**STATE OF RHODE ISLAND AND PROVIDENCE PLANTATIONS  
ENERGY FACILITY SITING BOARD**

**IN RE:    INVENERGY THERMAL DEVELOPMENT LLC    :**  
**APPLICATION TO CONSTRUCT AND               :**  
**OPERATE THE CLEAR RIVER ENERGY           :**       **SB-2015-06**  
**CENTER, BURRILLVILLE, RHODE ISLAND       :**

**CLEAR RIVER ENERGY LLC's SUPPLEMENTAL RESPONSES TO**  
**THE RHODE ISLAND DEPARTMENT OF ENVIRONMENTAL MANAGEMENT'S**  
**THIRD SET OF DATA REQUESTS, NOS. 3-21, 3-22 & 3-57**

**SINGLE SHAFT  
SITE LIGHTING LAYOUT**

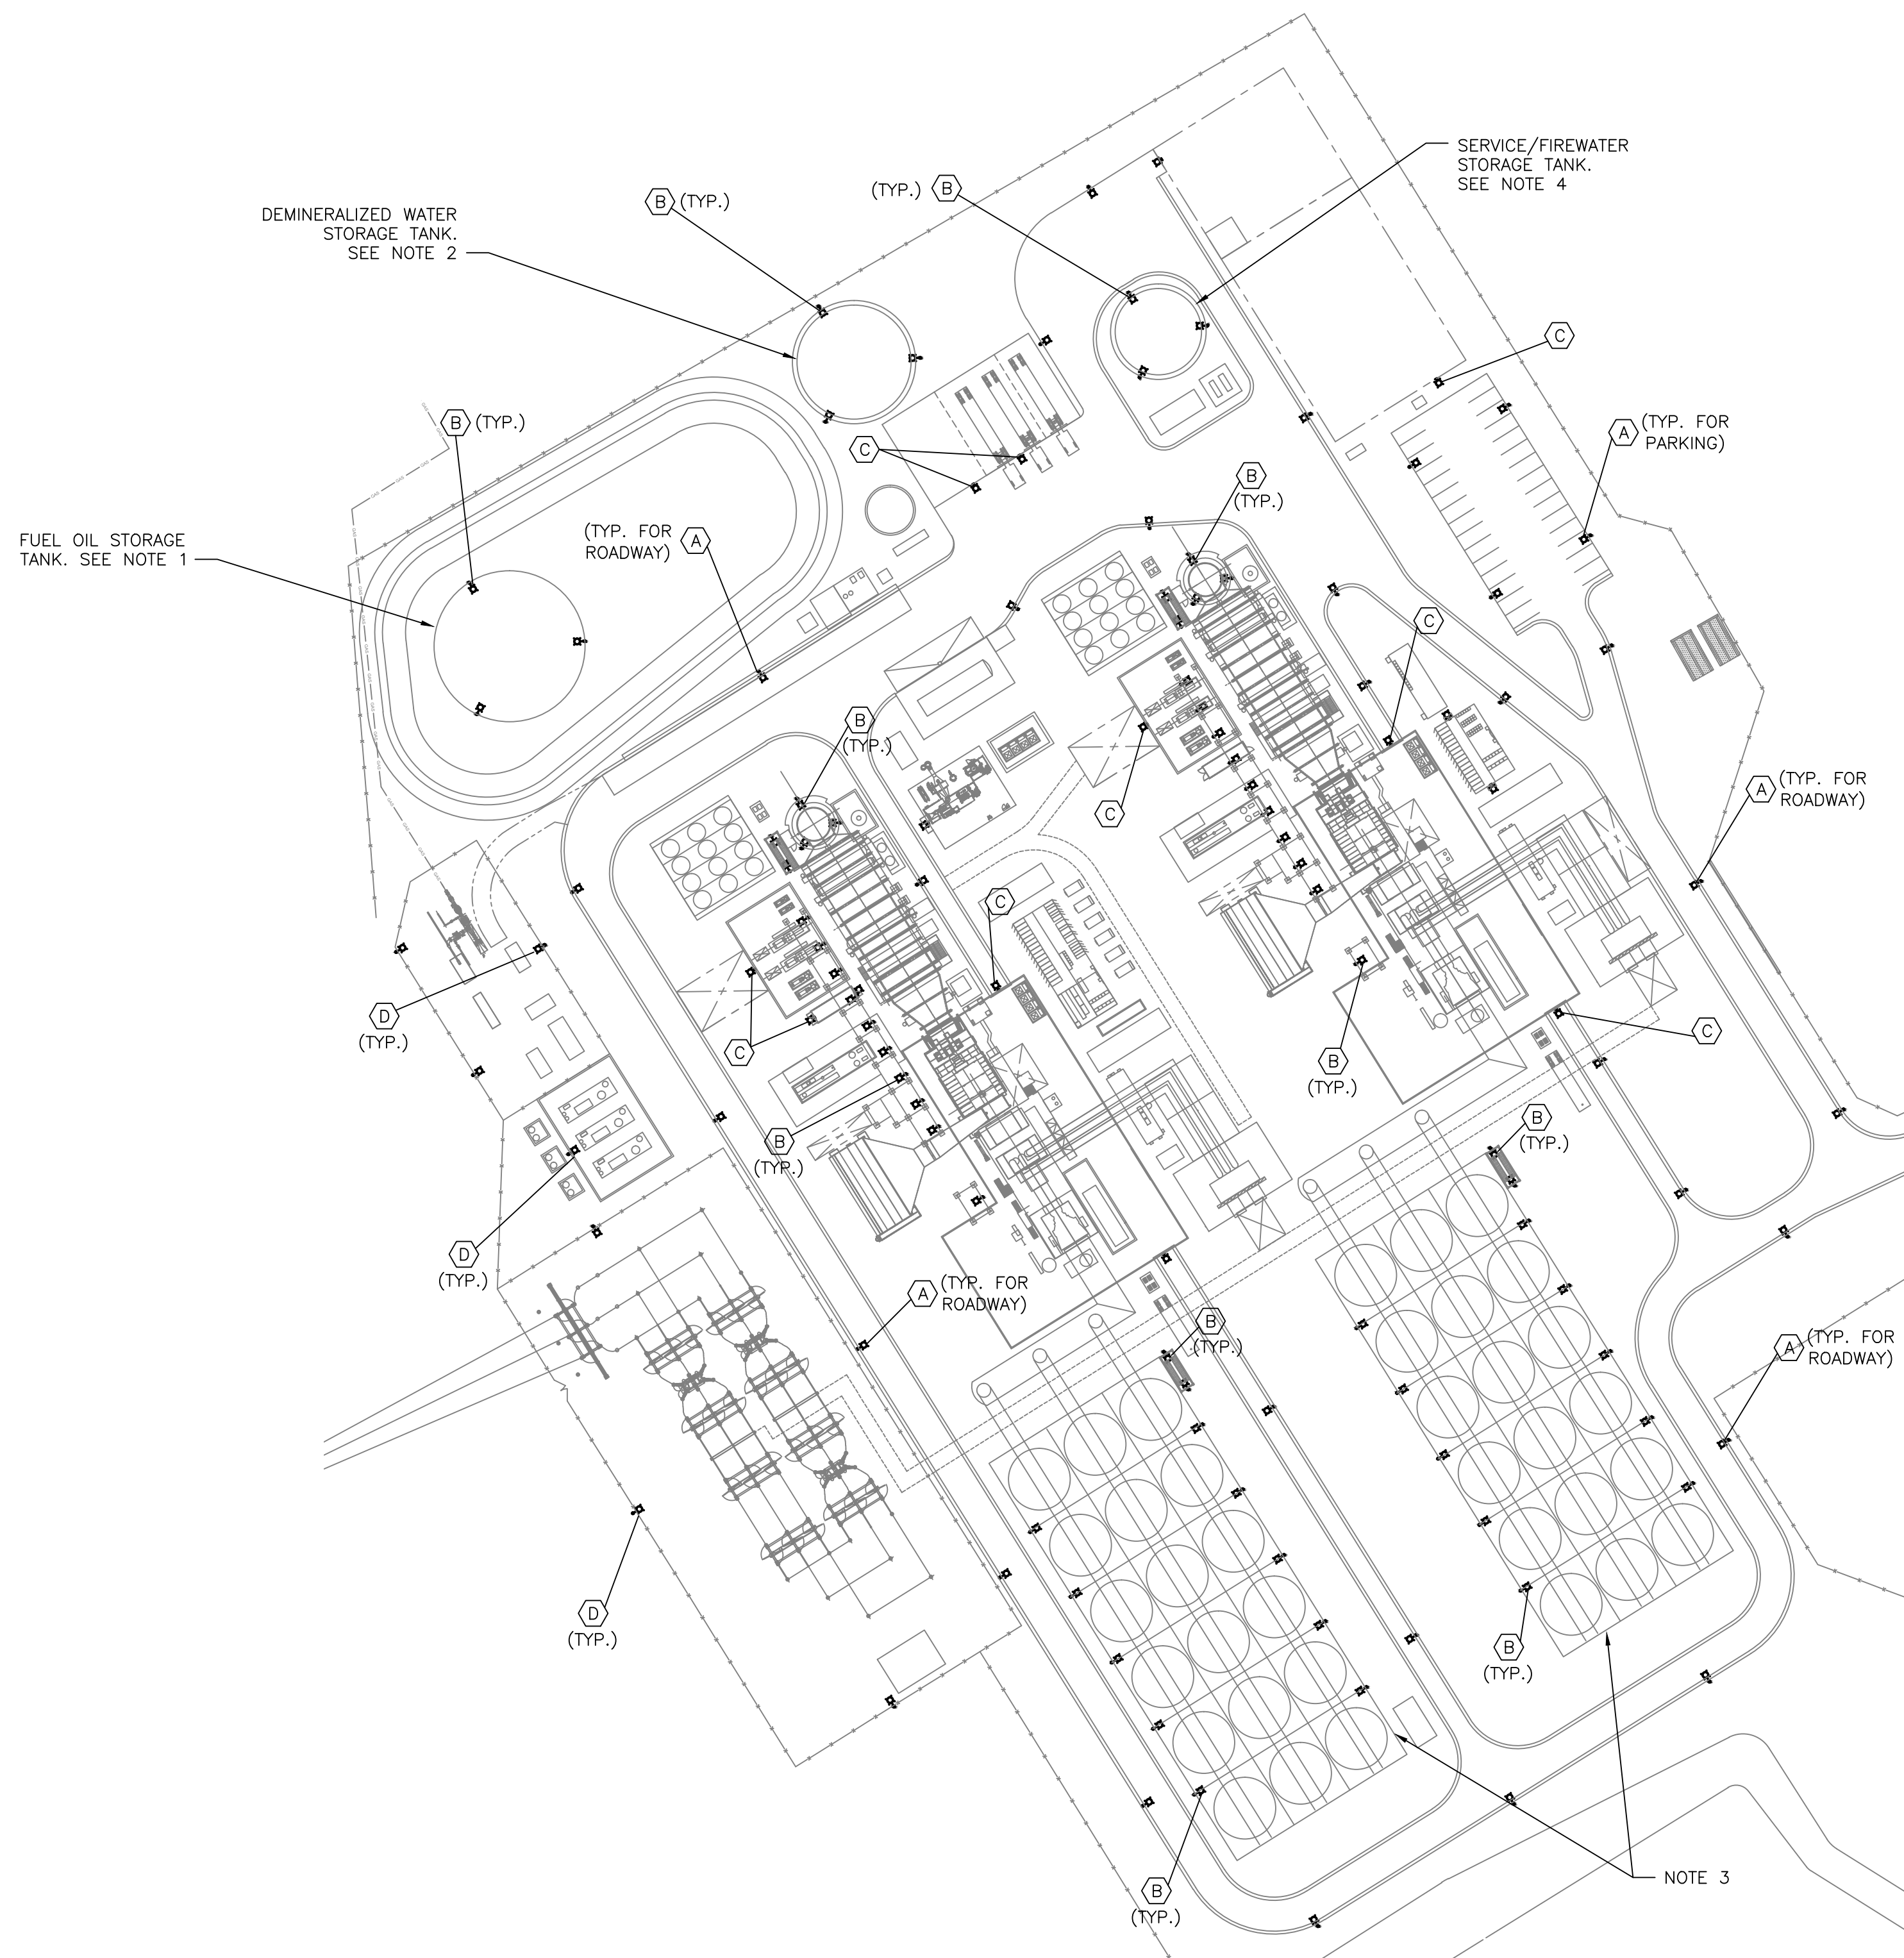
3-21                               Were light impacts to wildlife considered? Was light pollution considered in the calculation of a buffer distance into the forest from indirect impacts? Is lighting minimized to the greatest extent practicable?

3-22 Provide details of required site lighting, and describe what steps will be utilized to minimize lighting impacts or avoid light spillover into adjacent forested habitats from both the plant and the access road. Details should include, but not be limited to, lighting schedules, lumen output (based on need assessment); Correlated Color Temperature (CCT); fixture shields; and adaptive controls such as dimmers, timers, and/or motion sensors. Include all outdoor lighting, including any necessary on the stacks.

LEGEND  
 PROFILED FROM PHILIPS LUMEC  
ROADVIEW LED SERIES FIXTURE w/TYPE II  
DISTRIBUTION ON 30' POLE.  
FINAL FIXTURE SELECTION SHALL COMPLY  
WITH SPECIFICATION REQUIREMENTS FOR  
REDUCED WILDLIFE IMPACT (590-610 nm  
LIGHT LEVEL, CCT <3000K, & S/P RATIO  
<1.2)
